SCI 823 – High Fill Culvert Analysis

**Re: Bearing Capacity and Settlement Evaluation
(Culvert at STA. 404+13)
SCI-823-0.00 Portsmouth Bypass
DLZ Job No.: 0121-3070.03
Document # 0020**

PREPARED FOR: ODOT, District 9
PREPARED BY: Ram Nunna/Transystems
SUBJECT: Response to ODOT-9 comments on the Design of Four High
Fill Box Culverts dated June 22, 2007
DATE: July 19, 2007

This memo also documents the response to the ODOT review comments dated June 22, 2007.

Crossing: 234+05_239+18_IMPINL

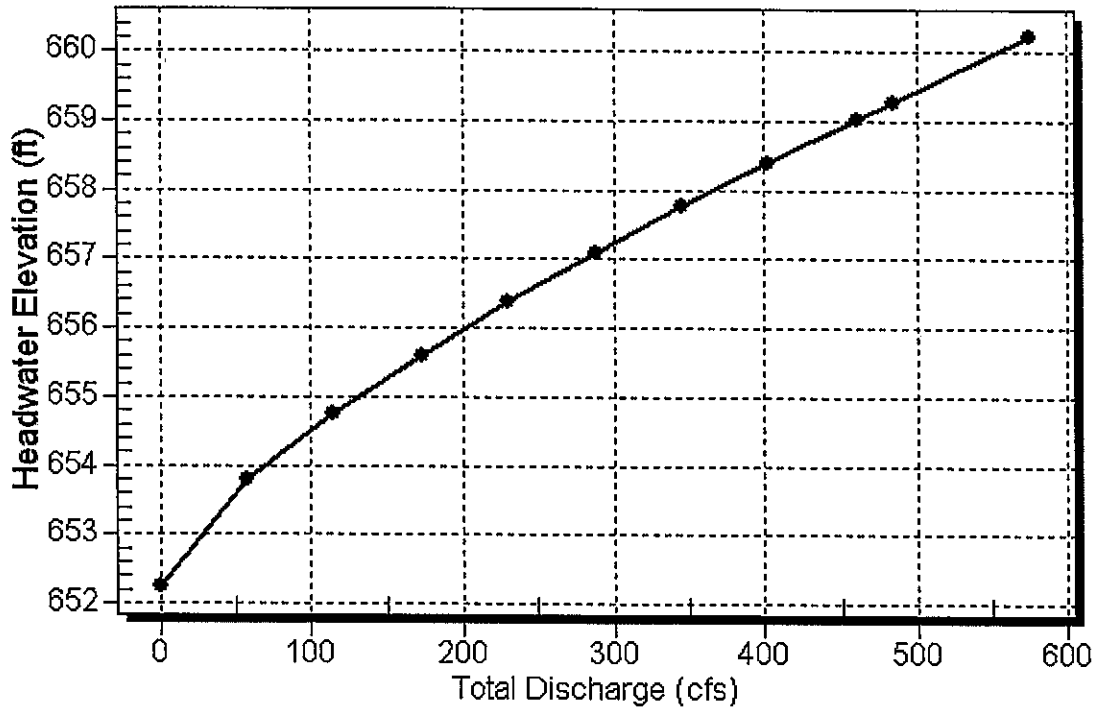
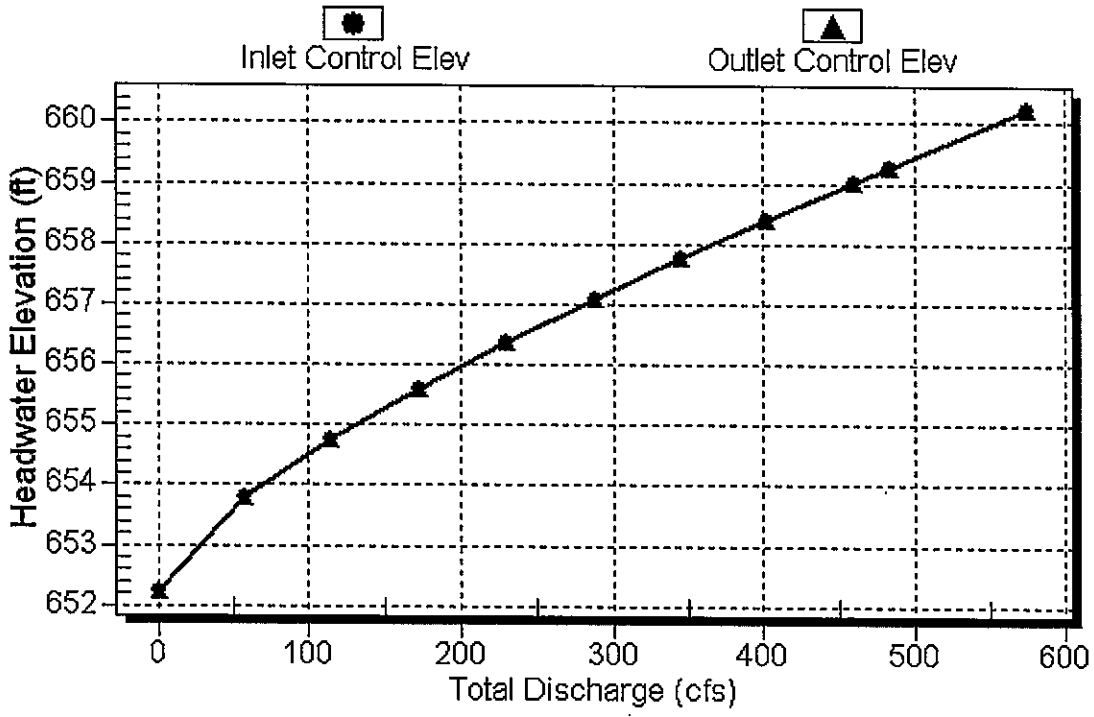
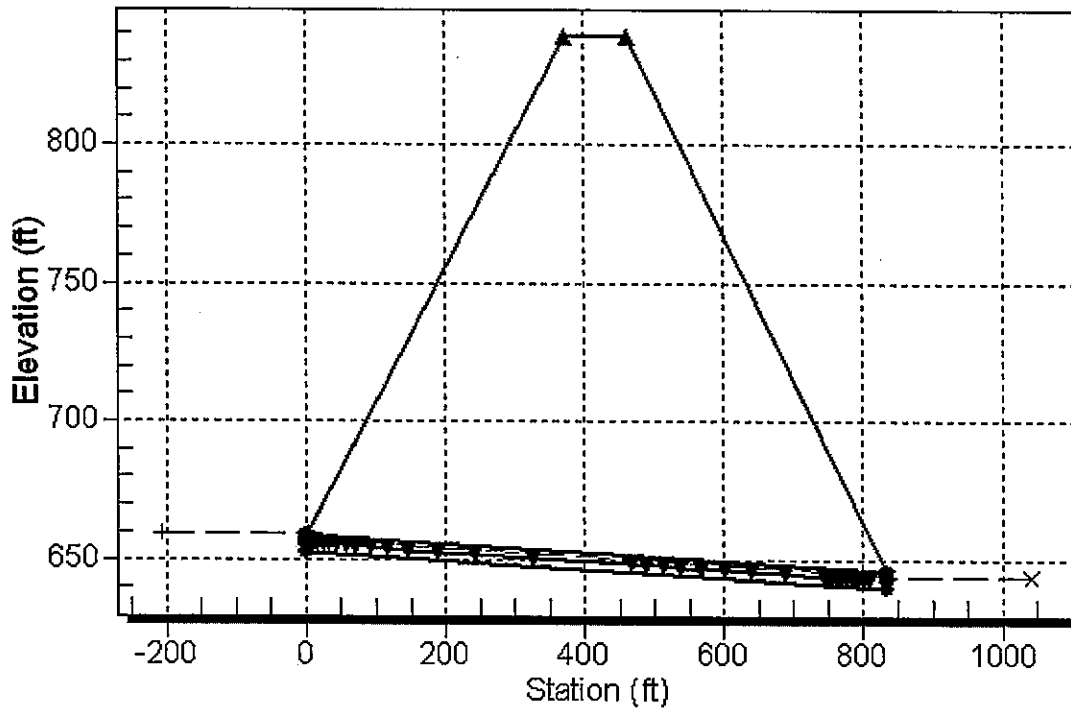
Comment # 2 Was there any consideration for improved inlets at each of the culverts? Would there be any reason why we could not use an improved inlet on the culverts, i.e. environmental considerations, etc.? The culvert size could be reduced with the application of these improvements. This in effect could provide considerable cost savings also.

Response#2: Improved inlets were not considered during evaluating the alignment options. However improved inlets can reduce the cost. See Appendix E for the summary of hydraulic analysis.

Crossing: 297+56_300+89_IMPINL

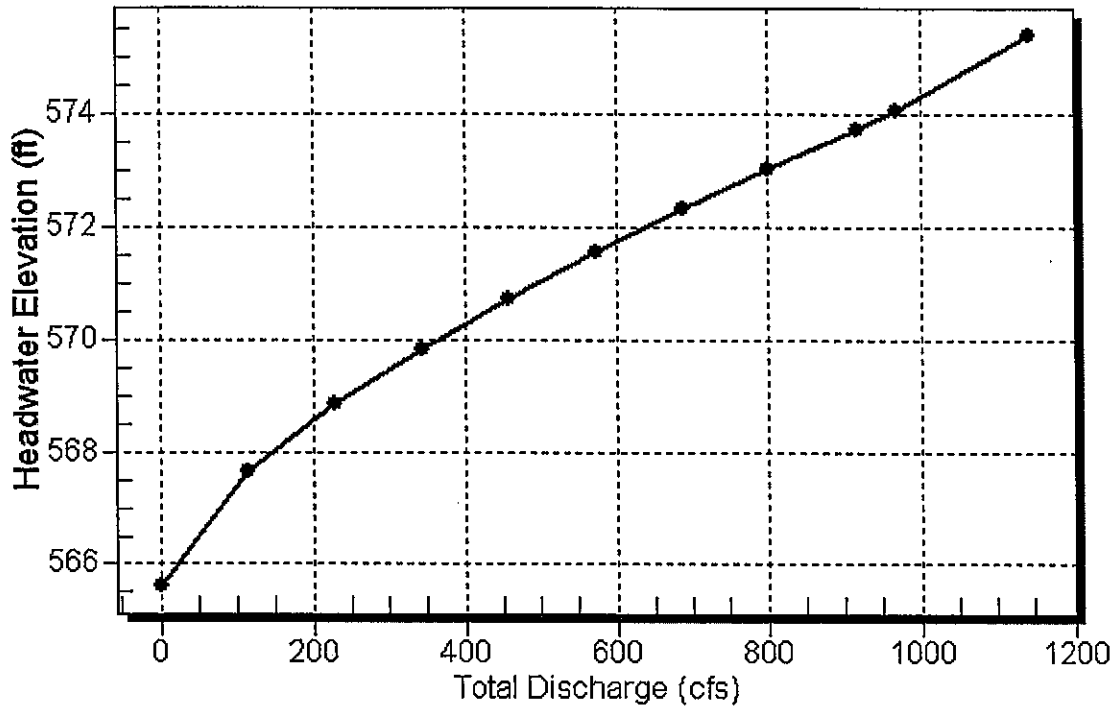
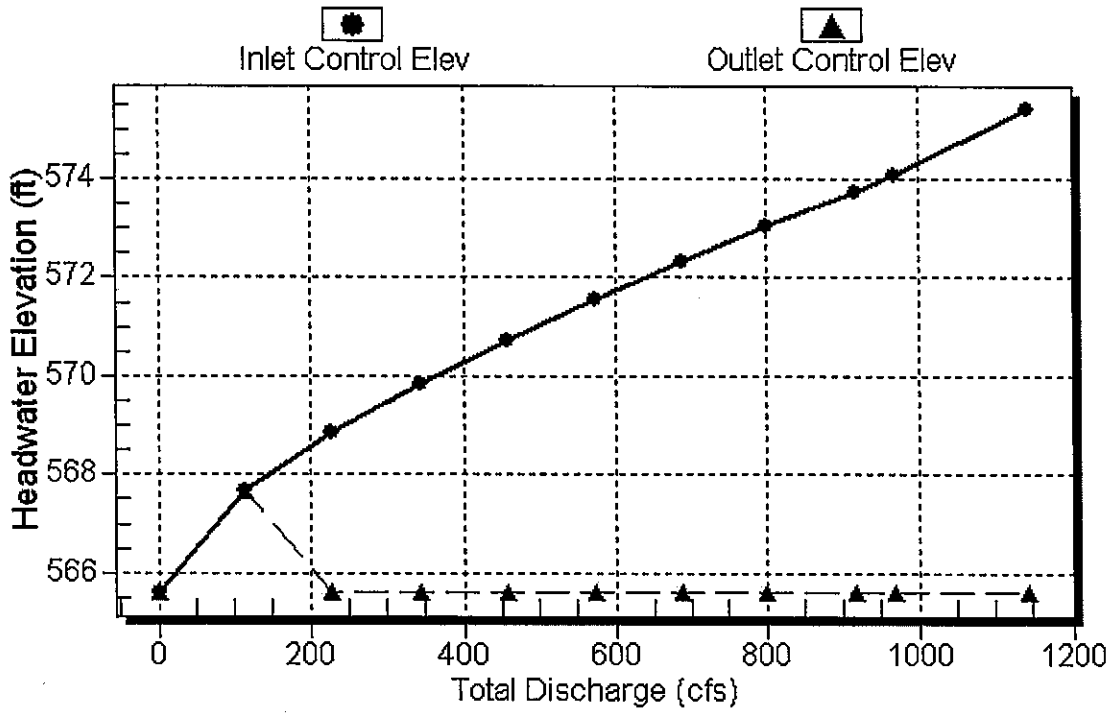
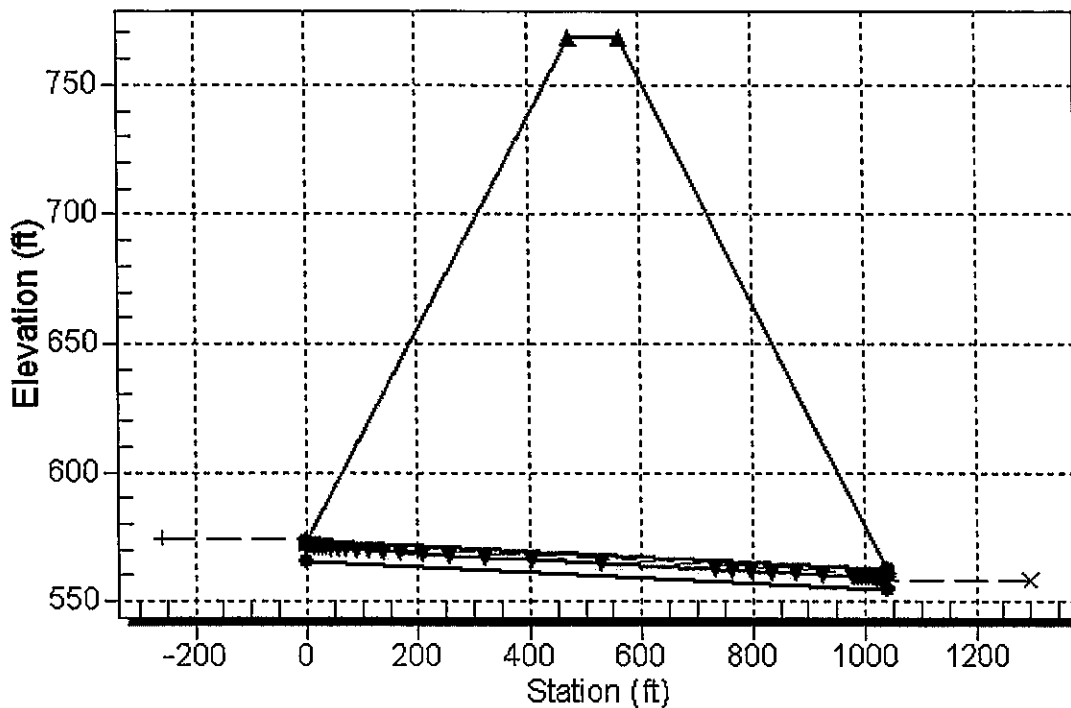
Comment#3 Was there any consideration for improved inlets at each of the culverts? Would there be any reason why we could not use an improved inlet on the culverts, i.e. environmental considerations, etc.? The culvert size could be reduced with the application of these improvements. This in effect could provide considerable cost savings also.

Response: Improved inlets were not considered during evaluating the alignment options. However improved inlets can reduce the cost. See Appendix E for the summary of hydraulic analysis
